## Service Bulletin

Date Issued	06 February 2001
Products Covered	VoicePrism serial number < 7002251
Issue	Some early units of VoicePrism have failed mic phantom power
Description	<p>The capacitor specified for mic input coupling has incorrect voltage rating. These capacitors should be removed on units returned for service. Audio performance is not affected by this modification.</p> <p>VoicePrism units shipped from Vtech before the above date are affected. Units manufactured after this date have been modified by ECO1248</p>

Illustration below shows location of C15 and C16. Front of unit is at bottom of illustration.

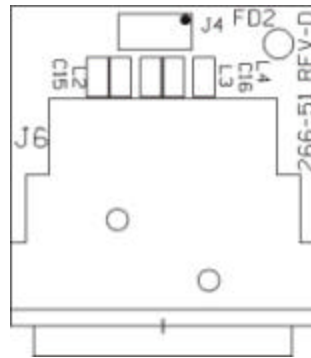
On units returned for service remove C15 and C16 from PDC0146 VoicePrism Display Board. Capacitors are located on mic input board behind connector J4. Illustration below shows location of board.
